AN ORDINANCE AMENDING ARTICLE 3 (DECISIONMAKING AND ADMINISTRATIVE BODIES), ARTICLE 5 (DEVELOPMENT PROCEDURES, REQUIREMENTS AND REGULATIONS), ARTICLE 6 (DEVELOPMENT REGULATIONS), AND ARTICLE 7 (MISCELLANEOUS PROVISIONS) OF THE VILLAGE OF ORLAND PARK LAND DEVELOPMENT CODE, AS AMENDED

Figure 6-208.H.1

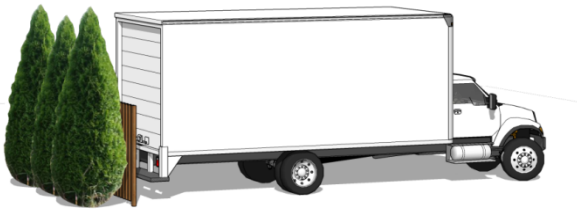
- m) Sub-Section 6-208.H. is amended by adding the following Sub-Section 6-208.H.2. (including “Figure 6-208.H.1.”), and re-numbering the remaining current Sub-Sections (2 and 3) accordingly:  
“

2. Outside storage of Automobiles and Commercial Vehicles and Trucks shall be prohibited except as follows:
- Parking of Automobiles as permitted by the Off-Street Parking regulations in Section 6-306 herein.
  - Temporary parking of Commercial Vehicles and Trucks in loading areas designed and designated for such purposes and for the purpose of loading and unloading.
  - Parking of Commercial Vehicles or Trucks essential to the operation of a business located on the same lot and with each Commercial Vehicle or Truck not to exceed 19,500 pounds. Outside storage of such vehicles shall comply with Sections 6-208.B.12, Section 208.H.1, and Section 6-308.J unless a special use is granted as per Section 6-208.C.9 herein.”

Figure 6-211.I.1

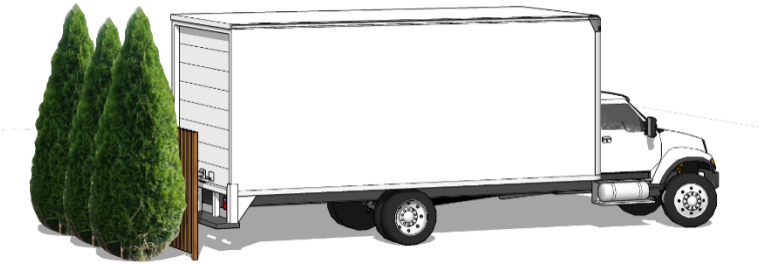
7. Outside Storage, for a storage area that does not meet the requirements of Section 6-211.B or Section 6-211.I. (See Section 6-308.J Screening and Section 6-302 Accessory Structures and Uses).”
- o) Sub-Section 6-211 is amended by adding the following Sub-Section 6-211.I., including Figure 6-211.I.1. and Exhibit A, as follows:

“I. Outside Storage of Vehicles. Outside storage of Automobiles and Commercial Vehicles and Trucks shall be prohibited except as follows:

- a. Parking of Automobiles is permitted subject to the Off-Street Parking regulations in Section 6-306 herein.
- b. Temporary parking of Commercial Vehicles and Trucks in loading areas designed and designated for such purposes and for the purpose of loading and unloading.
- c. Parking of Commercial Vehicles or Trucks essential to the operation of a principal building, located on the same lot, and with each Commercial Vehicle or Truck not to exceed 19,500 pounds. Outside storage of such vehicles shall comply with Sections 6-211.B.13, Section 211.H.1, and Section 6-308.J unless a special use is granted as per Section 6-211.C.7 herein.

Figure 6-306.H.1.

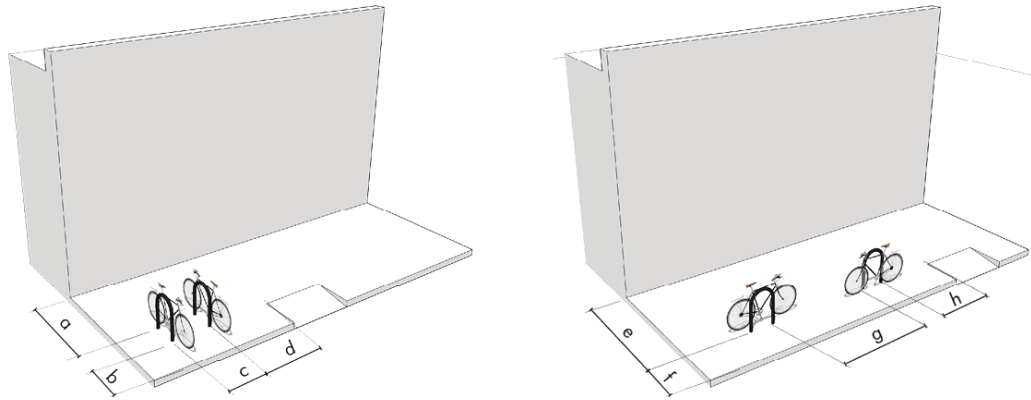
5. Bicycle racks shall be installed in conformance with the minimum spacing requirements shown in Figure 6-306.H.1.

- a. 7'-0" minimum from interior edge of sidewalk.
- b. 3'-0" minimum from rack to back of curb.
- c. 3'-0" minimum between centerline of racks.
- d. 5'-0" minimum from centerline of rack to other site elements.

- e. 5'-0" minimum from interior edge of sidewalk.
- f. 3'-0" minimum from rack to back of curb.
- g. 0'-0" minimum between racks.
- h. 5'-0" minimum from rack to other site elements.
